STAFF REPORTSAUSALITO CITY COUNCIL

Appeal of Akraboff Addition/600A Locust Street/DR 08-002

RESOLUTION OF THE SAUSALITO CITY COUNCIL DENYING AN APPEAL OF THE PLANNING COMMISSION'S APPROVAL OF A DESIGN REVIEW PERMIT FOR CONSTRUCTION OF A RESIDENTIAL ADDITION AND REMODEL AT 600A LOCUST STREET (DR 08-002)

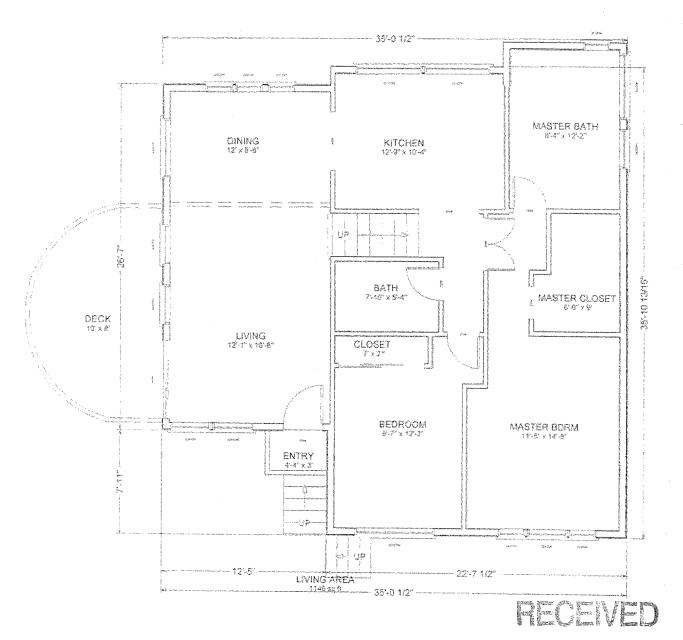
As promised, attached is a proposed compromise "Floorplan Solution" to Vanya's desire to expand and mitigation to our Primary View impact and myriad of other concerns. Combined with the lower roof line (of at least 4 feet) that you proposed, we believe this Floorplan Solution addresses many of ours and the other neighbor's concerns. It is important to note that this is only our opinion and we cannot speak for others. Given the tight deadline, we are sending this to you now and have solicited input from Mr. Beifuss. We want to share this with the other neighbors.

In short, the Floorplan Solution takes advantage of buildable area on the northwest side of the existing building. The Floorplan Solution is more efficient in terms of layout by significantly reducing interior hallways and keeping the entry stairs on the exterior of the building (in character with the neighborhood). The dining room and living room are pulled away from the private drive and the west wall is gradually stepped back to match the contour of the private drive. The deck is moved to the south side to capture better views while minimizing encroachment on Mr. Beifuss' privacy.

The deck is kept to a 10'x8' size.

The roofline is lowered by at least 4', as proposed.

- Room size impacts functionality so I'm grouping these two.
- With your design we have the same rooms but the functionality is gone.
- You removed the Entry space & Laundry room as well.
- You show the Kitchen 4' below the Hall. The Kitchen will be closed off from the rest of the house and will feel claustrophobic.
 - Your Dining Room will not adequately accommodate the table & the proportions of the room are off.
 - The 2nd Bathroom has no window. Natural light & fresh air a very important in a bathroom.
- The Master Bathroom may or may not work, I can't tell how functional the space is without doing some fixture layout.

- There is no clear circulation path.
- Your Entry appears to be outside? We have been able to provide not only an enclosed entry & in house laundry, but also access to & from the garage without going outside the residence. All of which your design has removed.
- With your layout you there is only one access to the Kitchen, creating a dead end. And you need to pass through the Dining Room to get there.
